Subject: [EXTERNAL]:Re: Re Notice of Hearing - Stack, 4-6 Silver Street, Durham

Noise

Safety

Appendix 1 – neighbouring residential properties

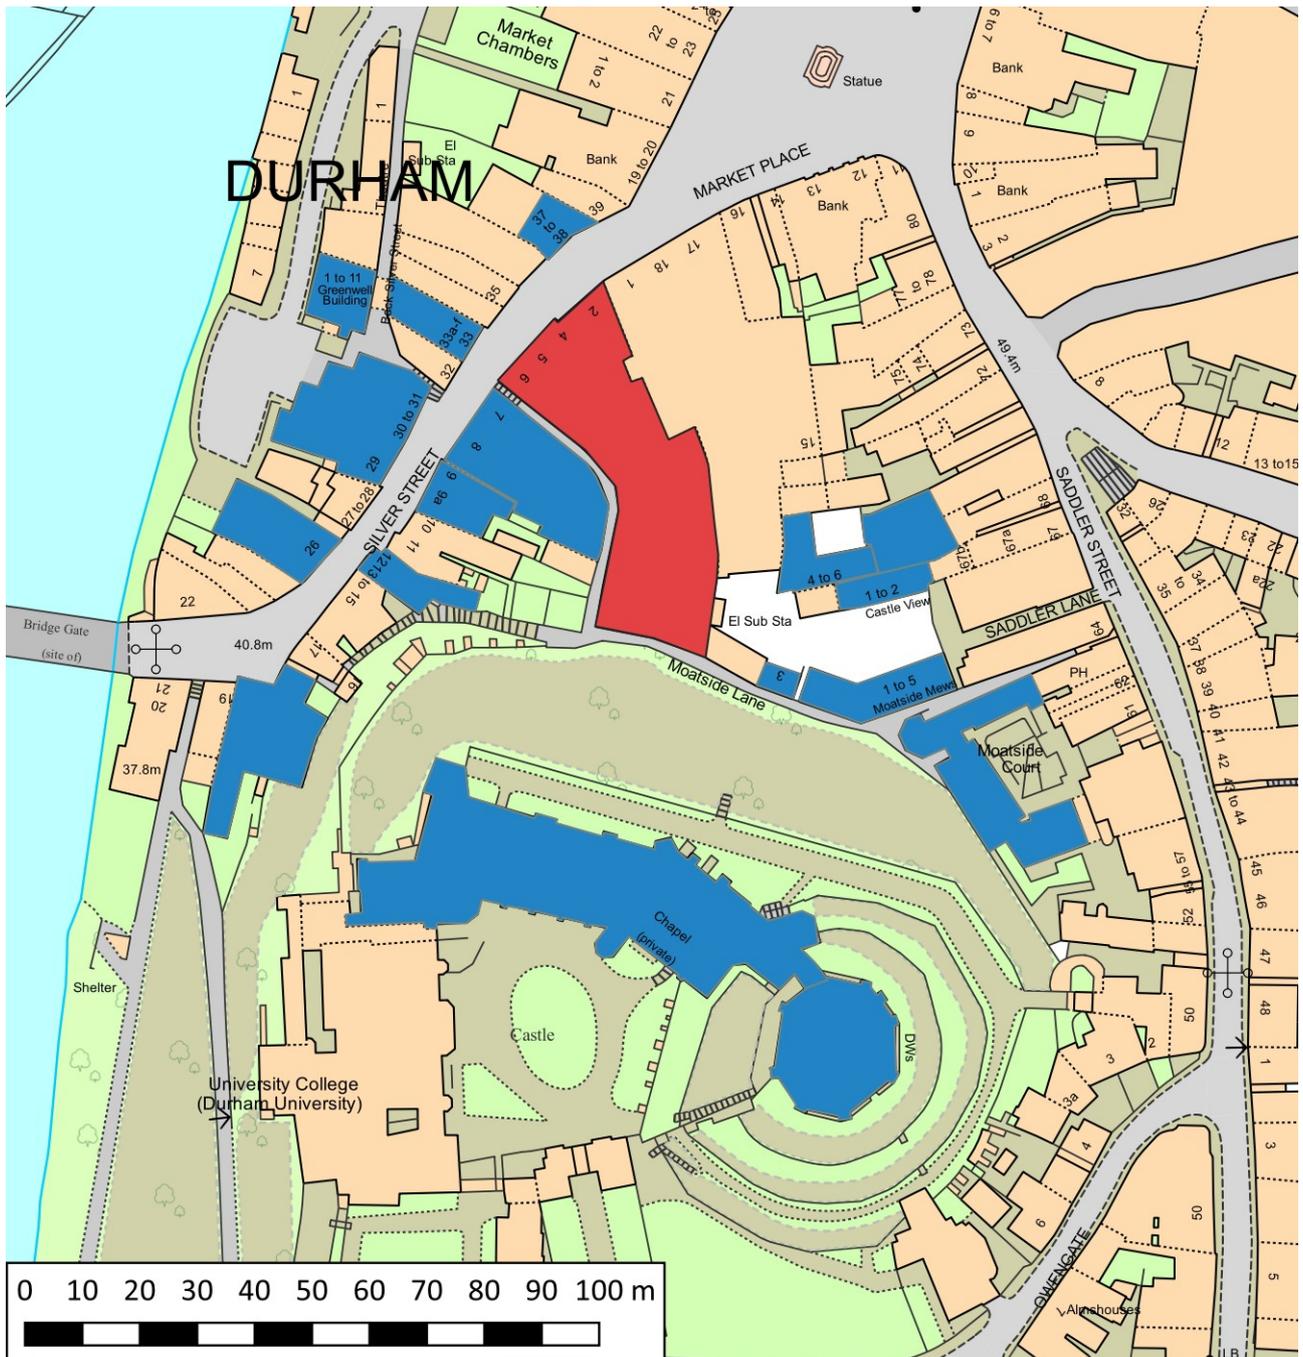
The map shows residential property (blue) in the vicinity of 4 - 6 Silver Street (red). Some are still under construction. Those approved in the past five years are

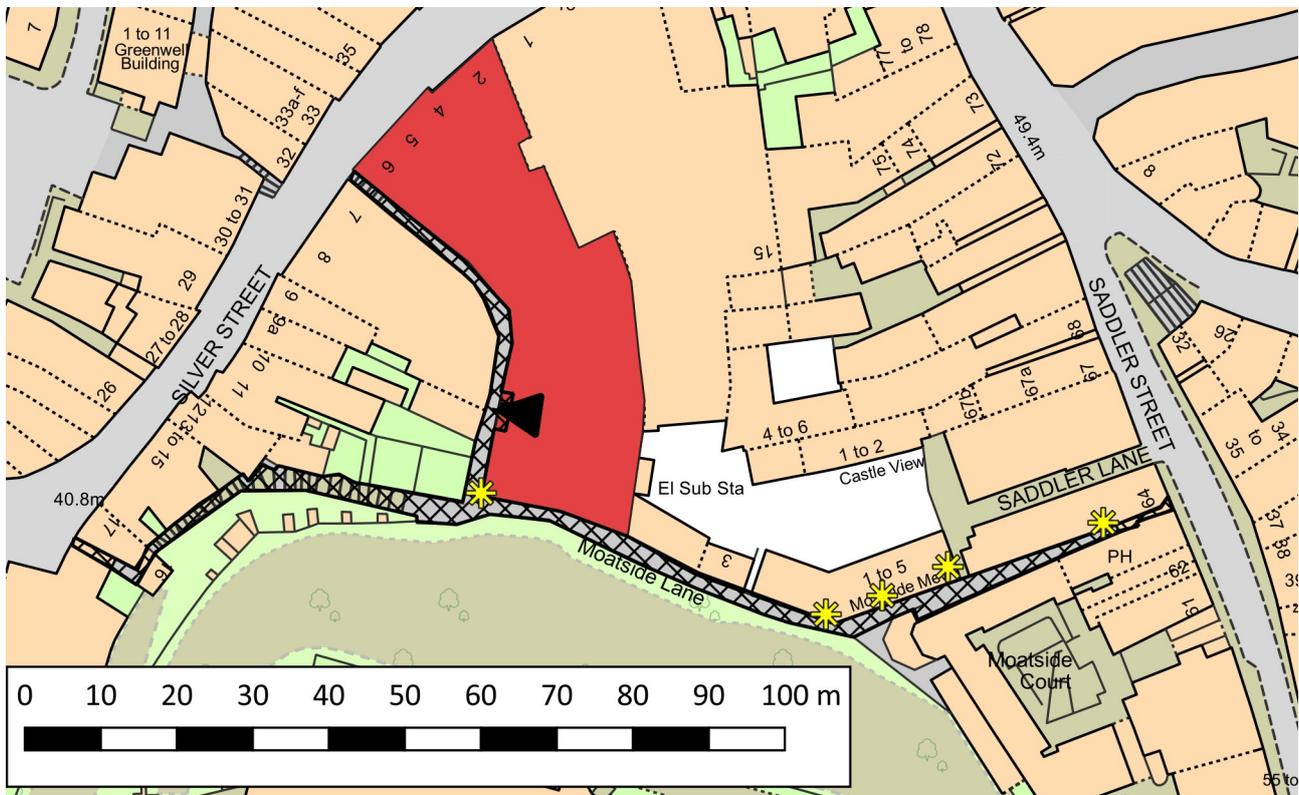
There are two adjacent fire escapes onto Moatside Lane, marked by an arrow in this plan:

This photograph shows two roller blinds where the exit will be. The plans accompanying this application show 150 people escaping via the narrower further door, and 410 via the nearer door. There is a note *Escape into narrow lanes to be reviewed by fire engineer.*

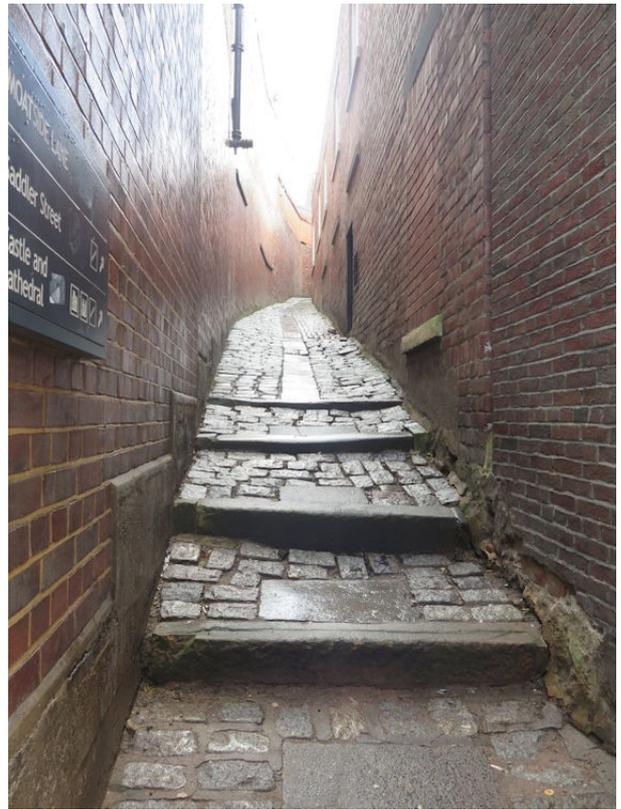
On exiting one may either turn left or right. It is possible to erect signage but in a panic few will see or take notice of it. With a press of people behind, this is a decision to be made quickly. Many or most visitors will not be familiar with Moatside Lane and its connecting paths which adds to the danger. The photo shows the right-hand route which leads to Silver Street, although due to the bend you cannot see it. This is the most direct route away from the exit.

The width of Moatside Lane narrows to 118cm, on the corner. The photograph on the left shows one this being measured. You will note that only the centre of the path is level. On either side the cobbles slope towards the middle.

The plans provided with the planning application show that there is a fall of 7.61m over the 41m from the fire escape to Silver Street. There are steps near to Silver Street, as the photograph on the right shows. When we visited there was a lot of broken glass and also dog faeces. People escaping may not be sober. They may be wearing high heels. The path may be wet and slippery. Funnelling crowds into a confined space is a recipe for catastrophe, Anybody falling may well be crushed and serious injury or death could result.

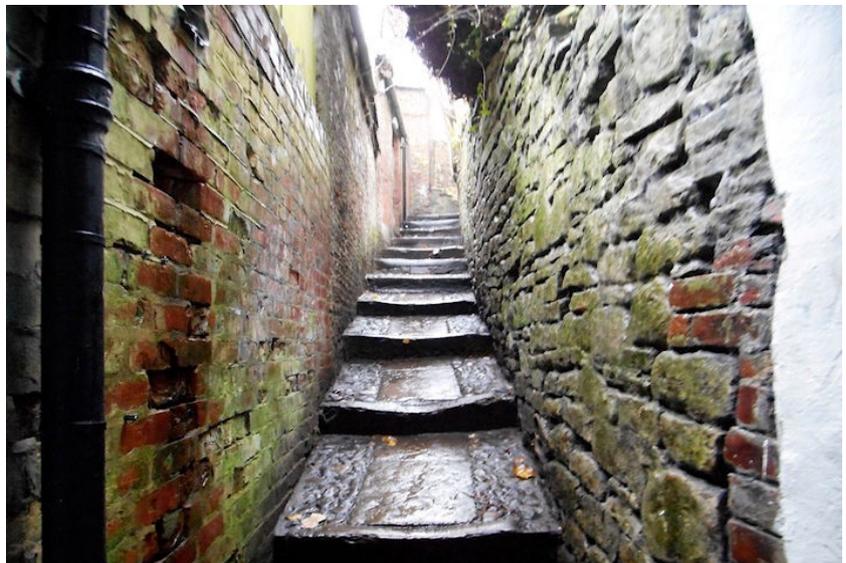
Turning right here leads via a narrow path with steep steps (see photograph) and a corner down to the foot of Silver Street. This is not something to be attempted after dark due again to the risk of falling and being crushed.
